City of Albuquerque Environmental Planning Commission

Staff Report

CASE #: SP-2026-00044

CASE SUMMARY: This request is a Site Plan – EPC for the Albuquerque Bernalillo County Water Utility Authority (ABCWUA) to develop a water reuse system (i.e., major utility use) in the Mesa del Sol Community Master Plan Employment Center I boundaries.

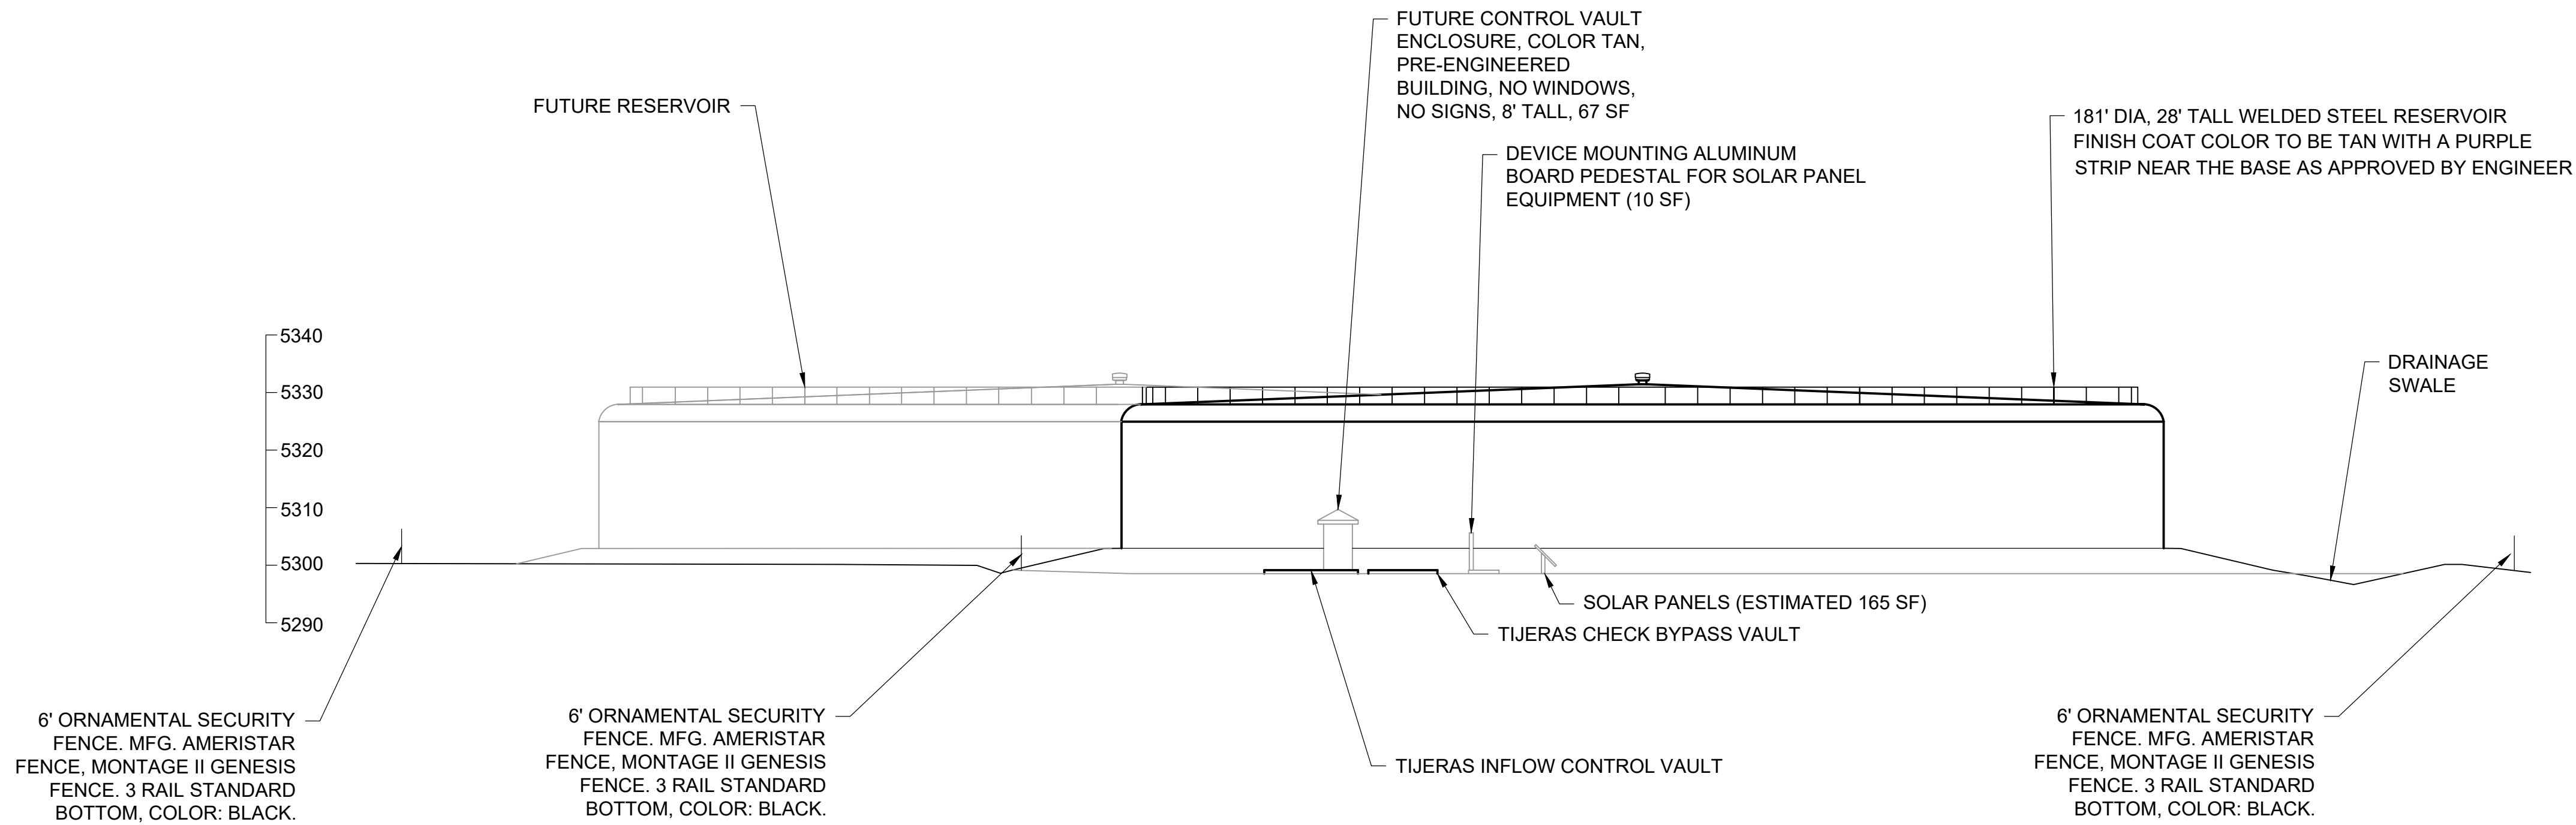
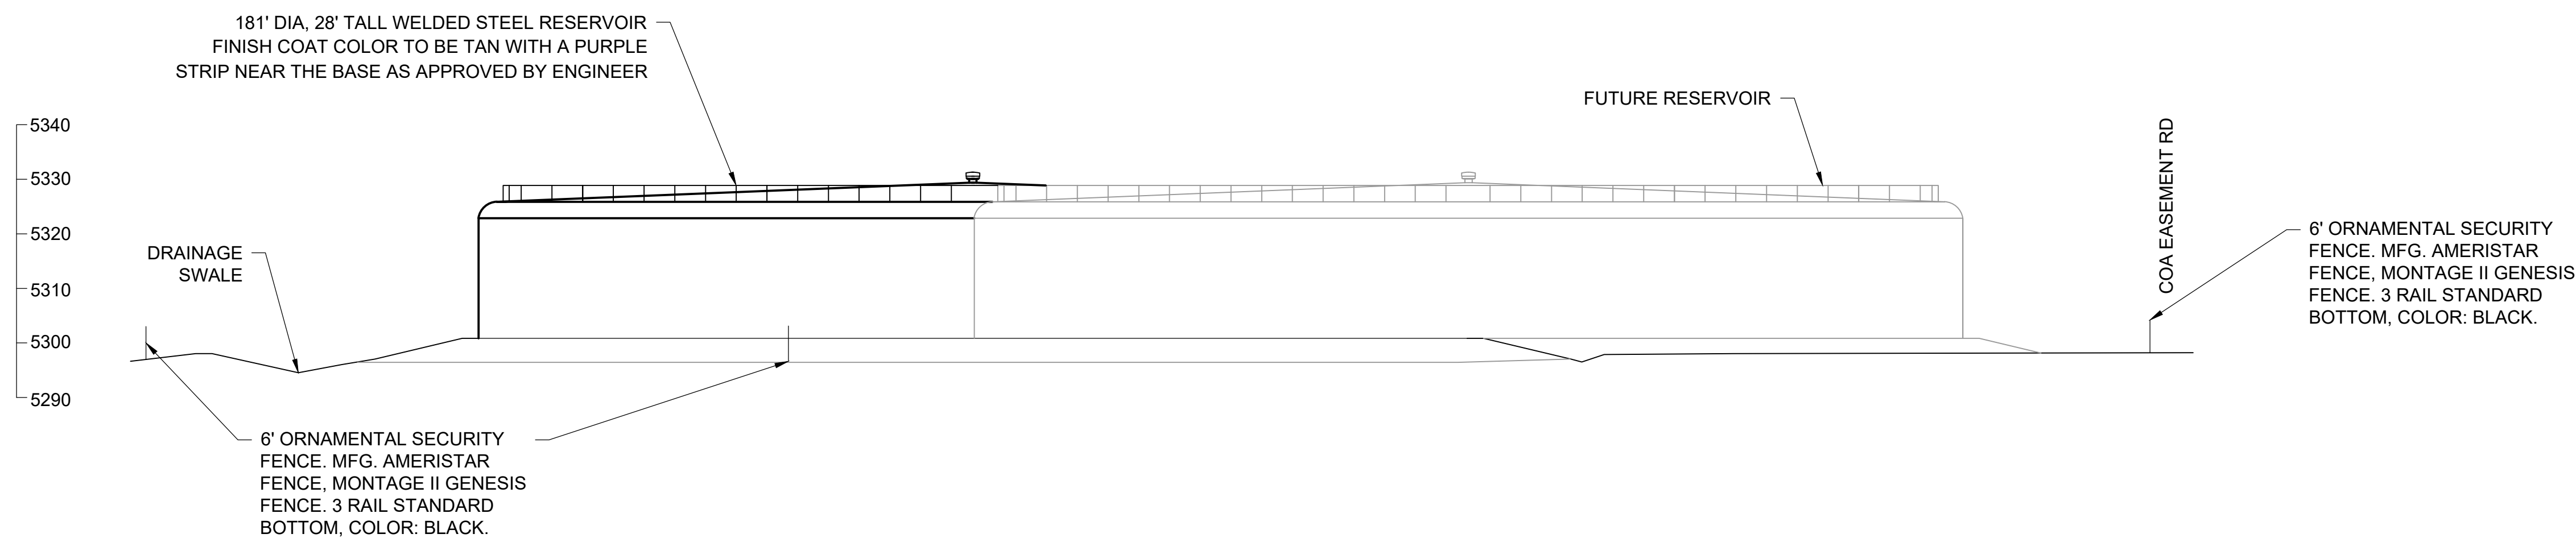
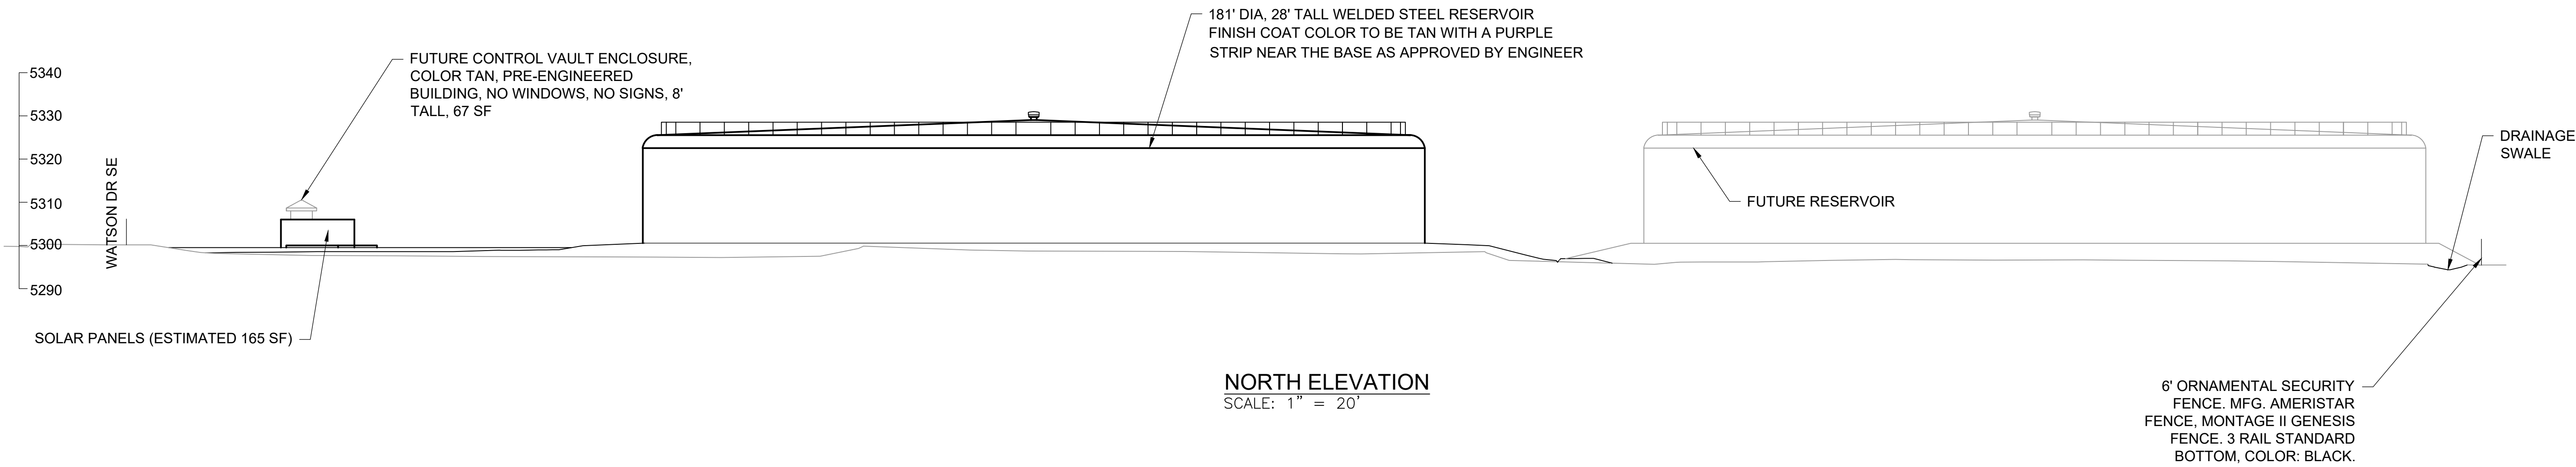
- For example: Exhibit 5.0 – Building and Structure Elevation – Please remove the existing cell tower and any structures not on 5430 Watson Dr. SE. The cell tower on this sheet could cause confusion amongst others as it appears to be a part of the subject site.
- Is Exhibit 3.5 needed for Grading/Drainage approval? If not, consider removing. – **Sheet is needed, please disregard, however, please continue to review site plan for any sheets that could be a distraction from the subject site/project. - DS**
- Verification – Are there any lights on the subject site? – **No lights/no parking - DS**

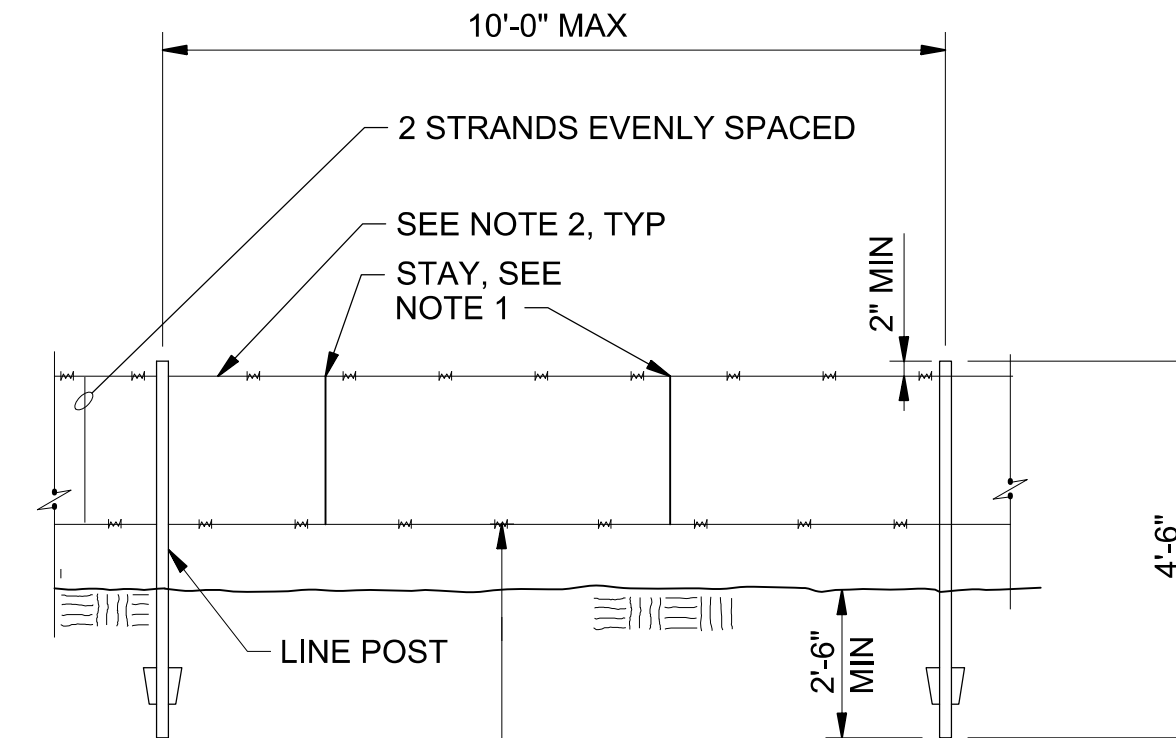
Additionally, the subject site has proposed a 4' tall, temporary wire fence to serve as a barrier to protect the landscaped reclamation seeding from pedestrian and vehicular traffic. The temporary fence borders all landscaped areas and a note is included on the site plan which states "Barrier shall remain in place for 24 months after acceptance of the project or until the vegetation has reached self-sustaining maturity" (Sheet 5.4).
